Abloom Design Ltd

10th June 2014

Executive Summary

Building 2 – Ground Floor Plan

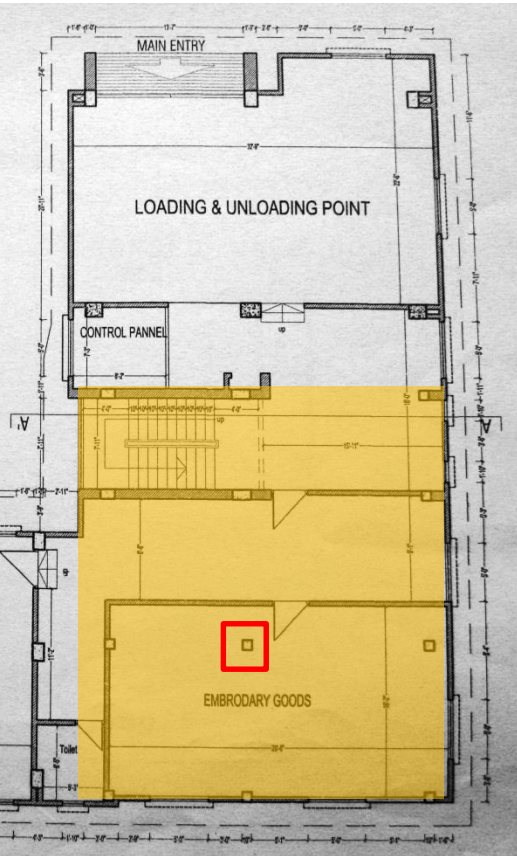
Columns in Building 2 appear to be stressed to a high level and require review including immediate action

Cursory calculations indicate that the working stress in the columns of Building 2 is at a level which requires immediate review. **Area of Building 2 to be vacated immediately (Refer to Page 4 of this report)** and Detail Engineering Assessment required.

Immediate Action;
Imposed loading in the area highlighted, including personnel, equipment and storage loads, is to be cleared at all floor levels with immediate effect.

Building 1 – Ground Floor Plan

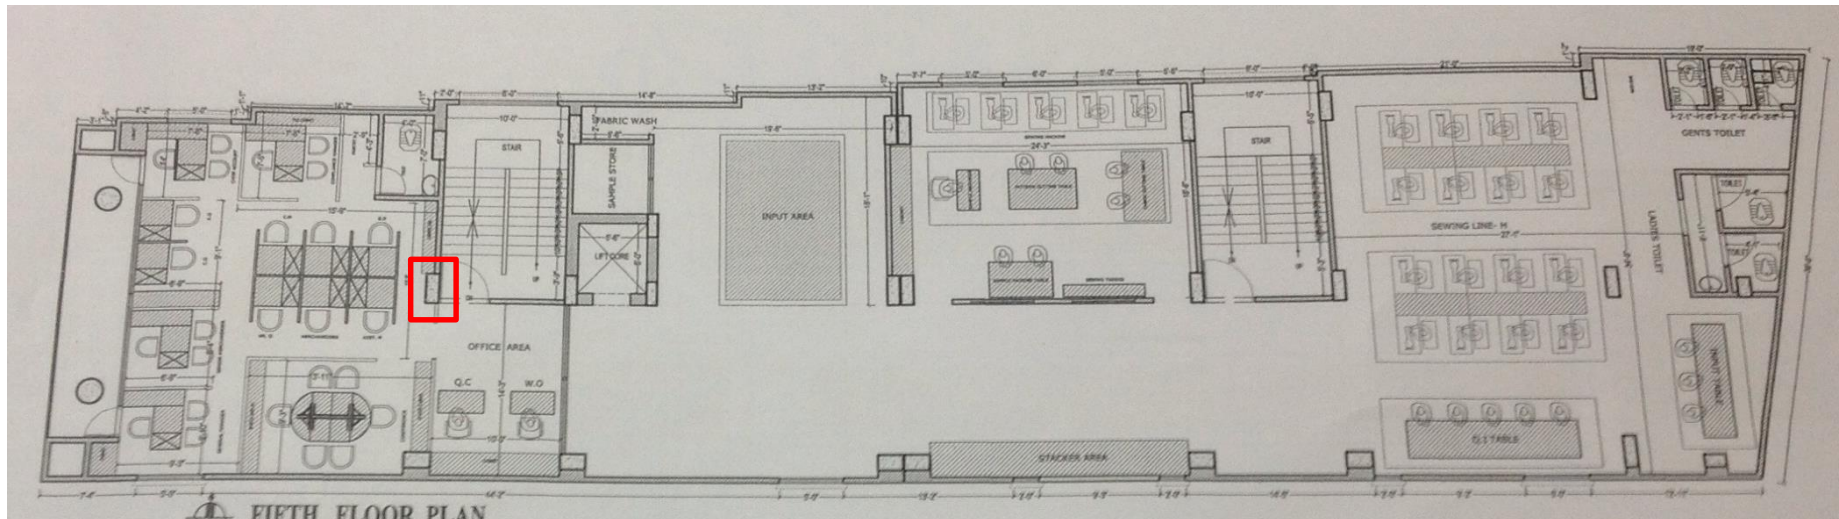
**Columns in Building 1 appear to be stressed
in excess of normal design limits**

Cursory calculations indicate that the working stress in the columns at Ground Floor level of Building 1 is above normal design limits.

Exposed Column G.L. E / 2

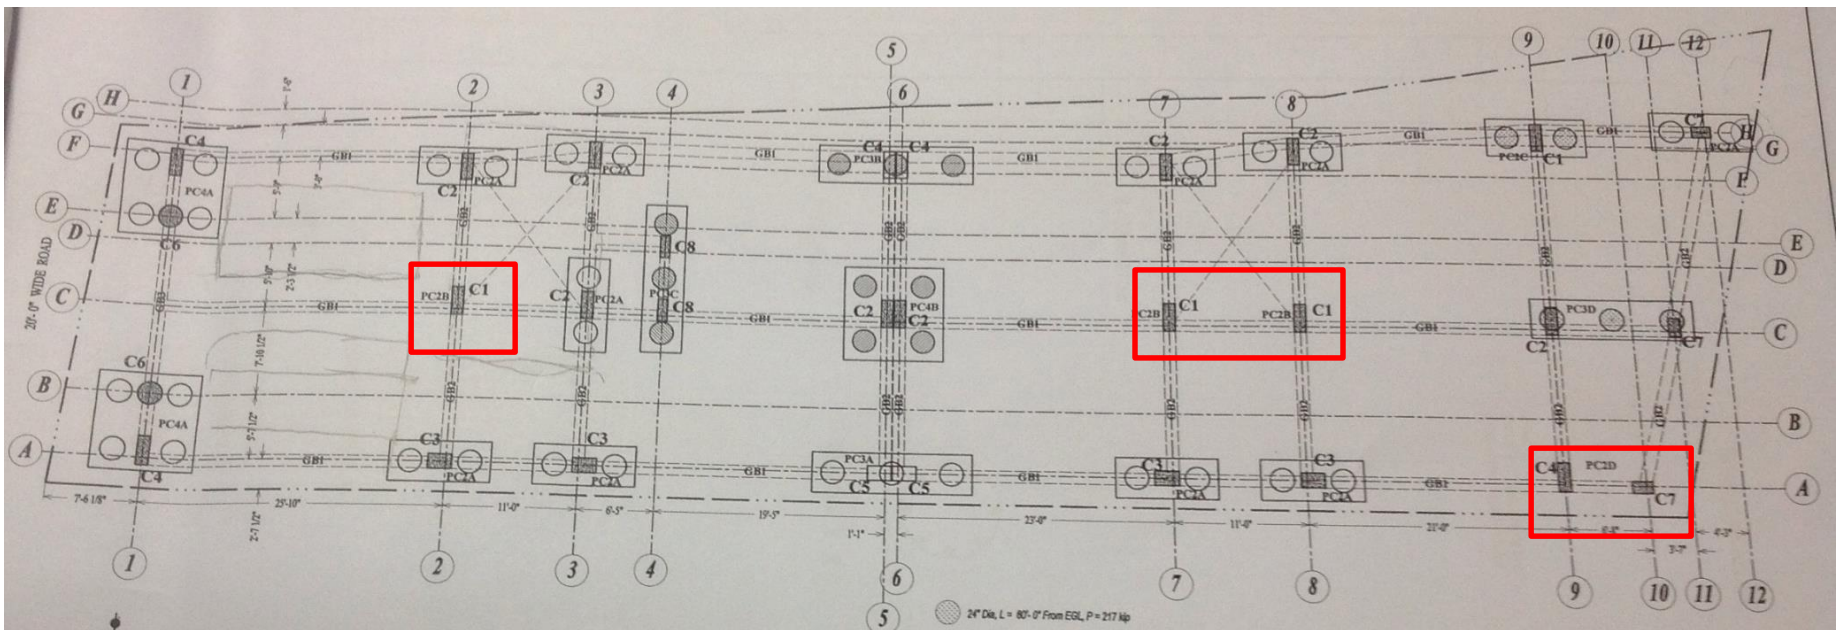
Hairline cracks were noted to column head. This prompted the removal of plaster, which appeared to reveal the concrete column finishing approximately 500mm short of the slab and bricks used thereafter.

Building 1 – Piled Foundation Layout Plan

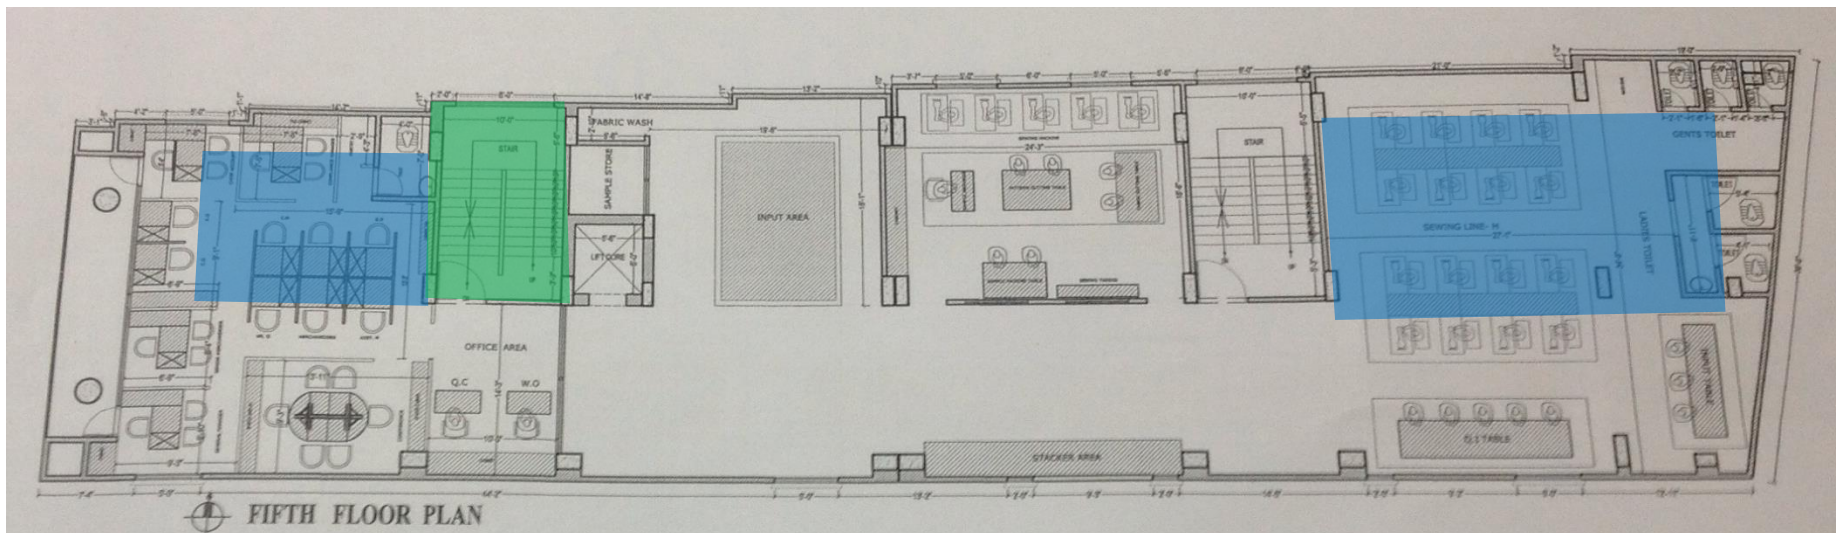
Foundations missing at key column locations. Supporting documentation for a transfer structure below Ground level which spans between adjacent foundations, as suggested by Engr. Md. Ali Hossain Majumder, was not provided.

Building 2 – Slab reinforcement layout for 1st, 2nd & 3rd Floor levels

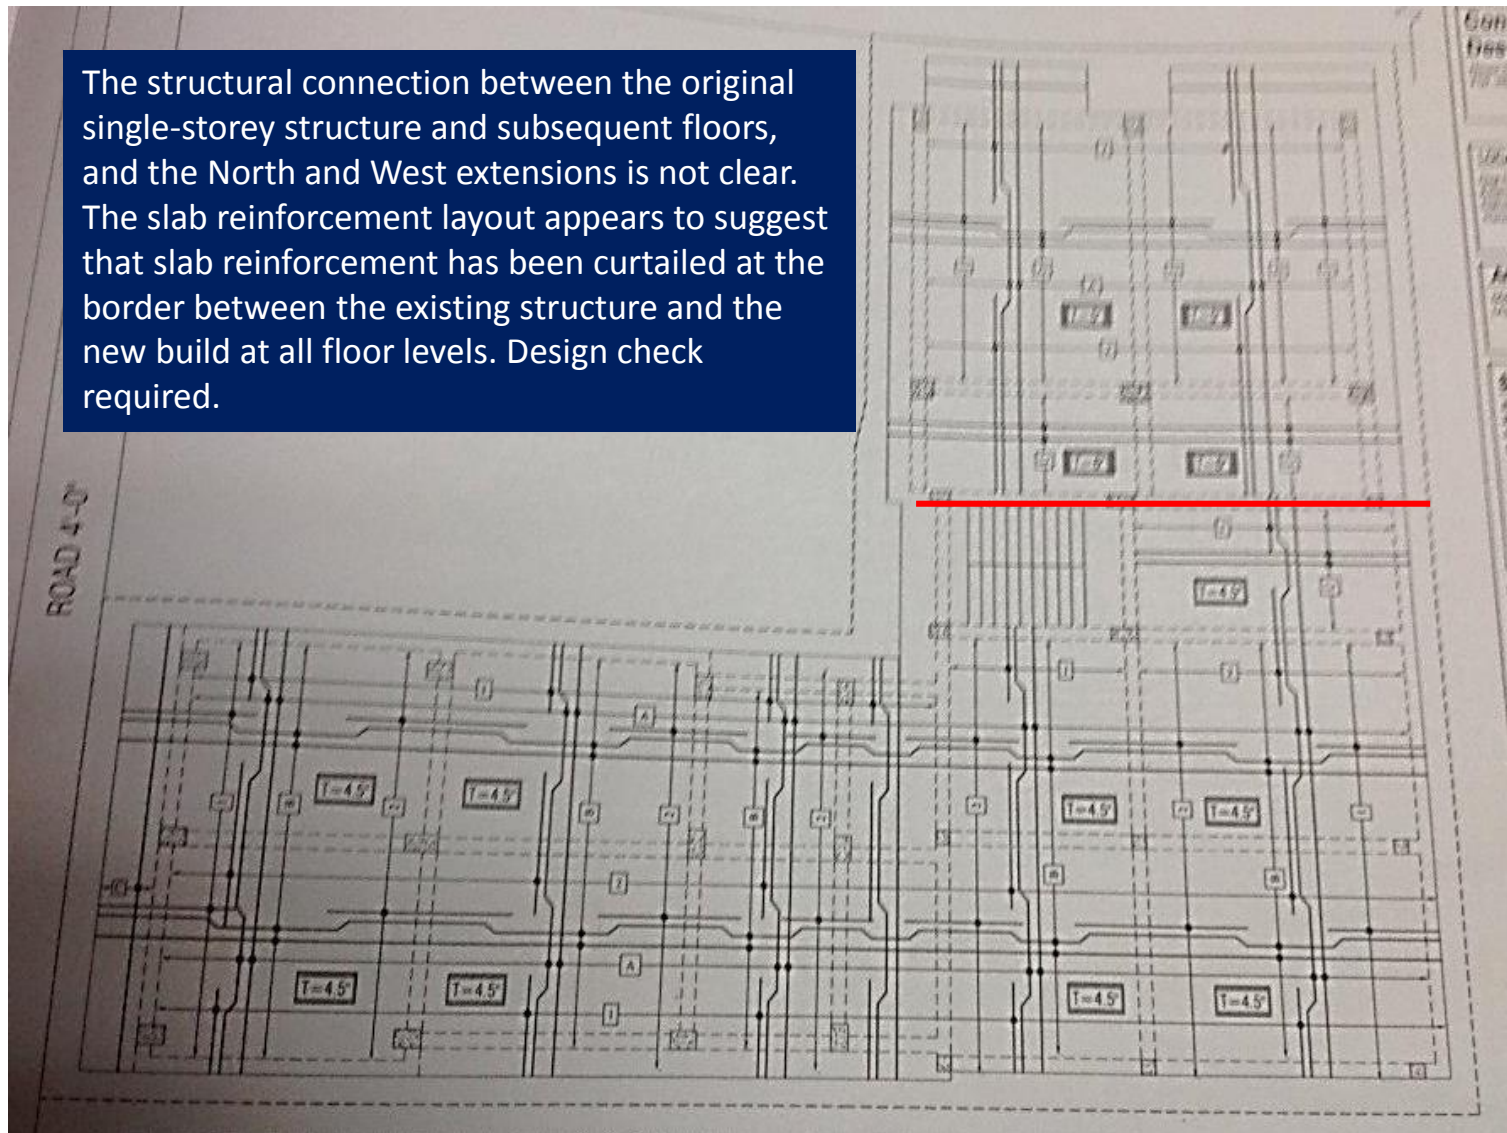
The structural connection between the original single-storey structure and subsequent floors, and the North and West extensions is not clear. The slab reinforcement layout appears to suggest that slab reinforcement has been curtailed at the border between the existing structure and the new build at all floor levels. Design check required.

Actual slab footprint at 6th Floor & Roof

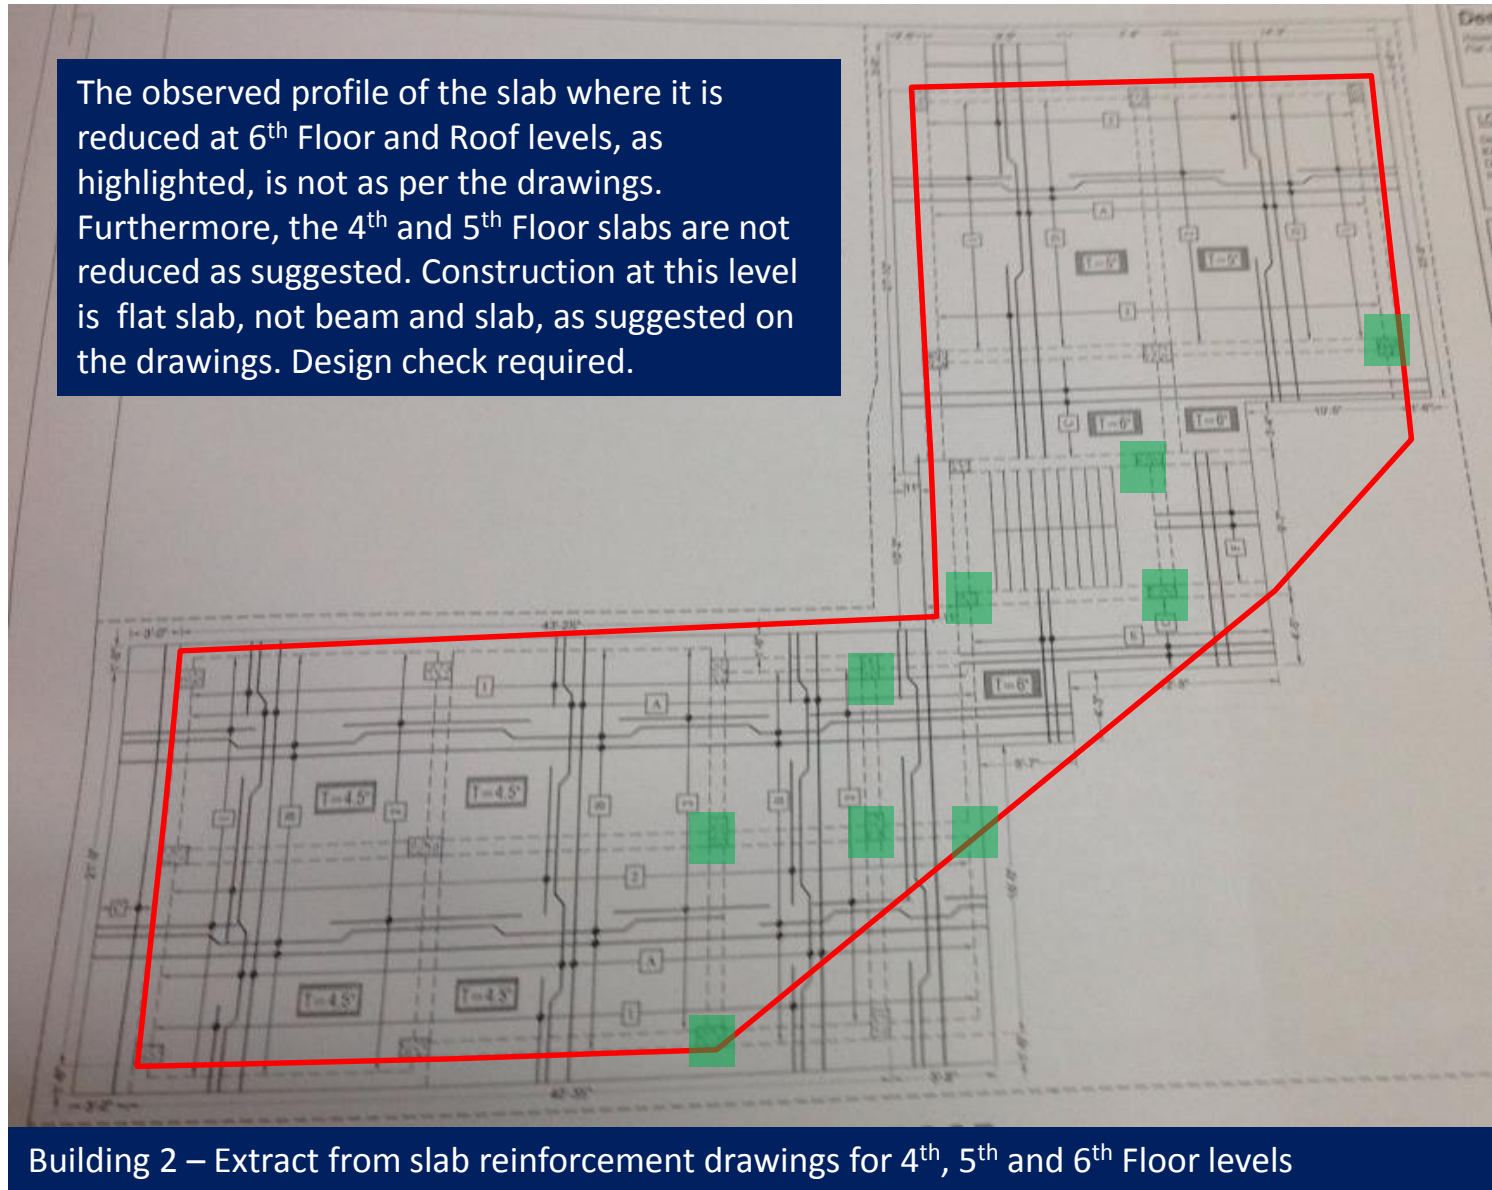
The observed profile of the slab where it is reduced at 6th Floor and Roof levels, as highlighted, is not as per the drawings. Furthermore, the 4th and 5th Floor slabs are not reduced as suggested. Construction at this level is flat slab, not beam and slab, as suggested on the drawings. Design check required.

Building 1 – Typical Floor Plan

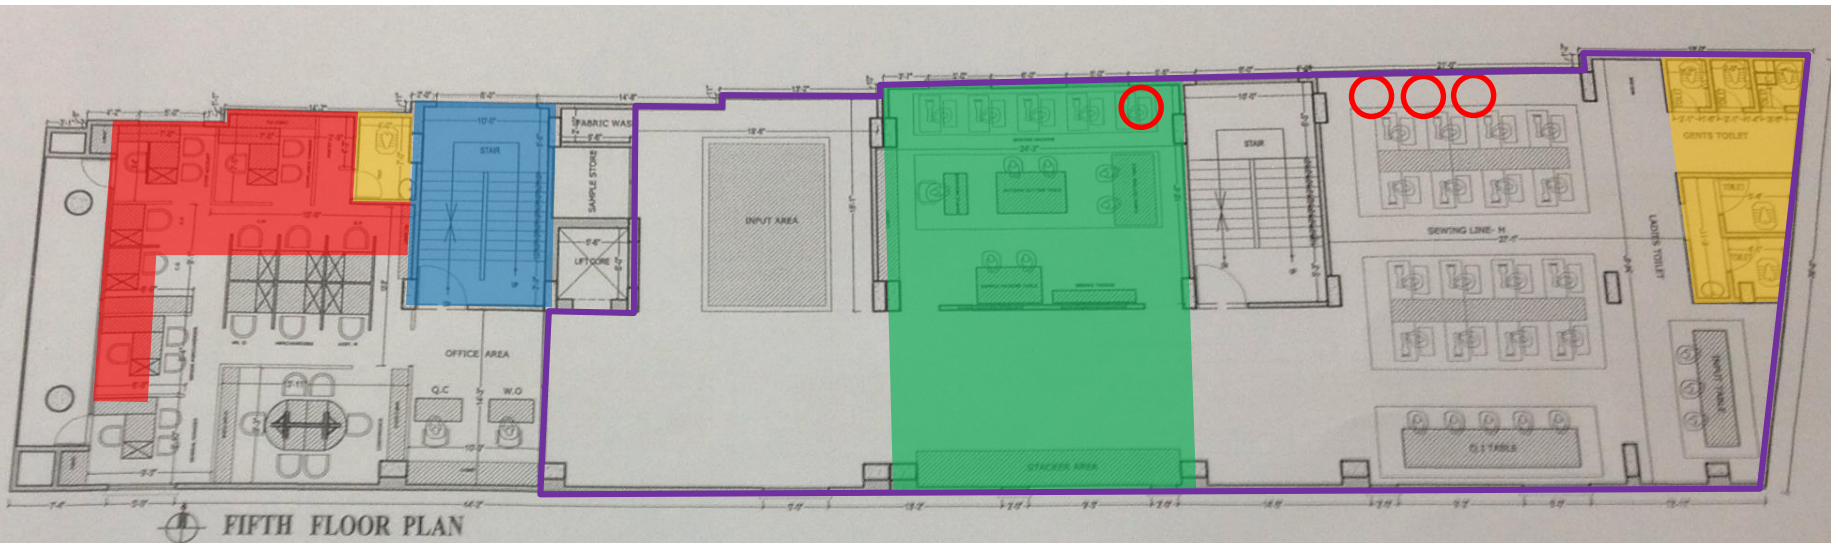
Heavy loading was observed in the fabric storage area at 1st Floor level of Building 2. Further areas of high loading were noted at the water tanks at roof level and 6th floor level of Buildings 1 and 2, respectively, and at the storage areas to Mezzanine and 7th floor levels of Building 1 and to 5th and 6th Floor levels of Building 2.

Building 1 – Roof Plan

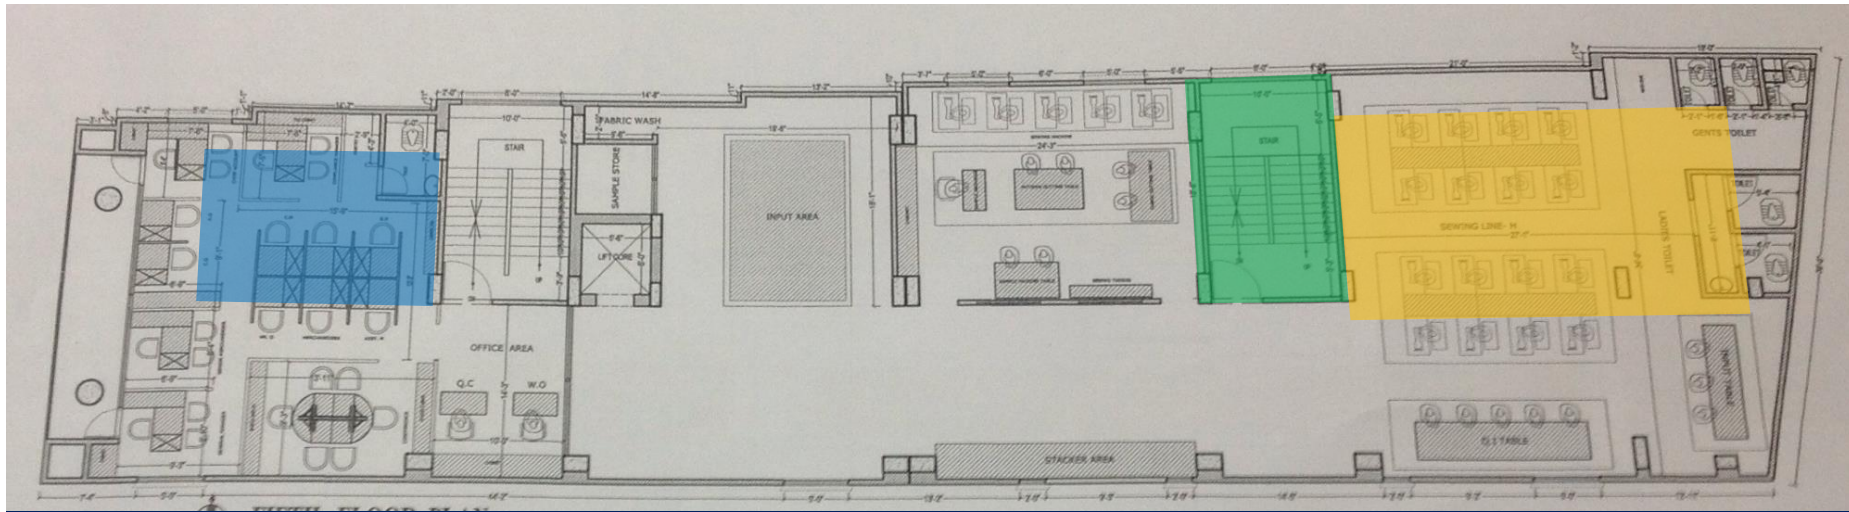
There are a number of lightweight roof structures, located at the Maintenance Rooms and the eastern stair core of Building 1. These appear to be non-engineered and may not be adequate to resist design uplift forces and lateral loads.
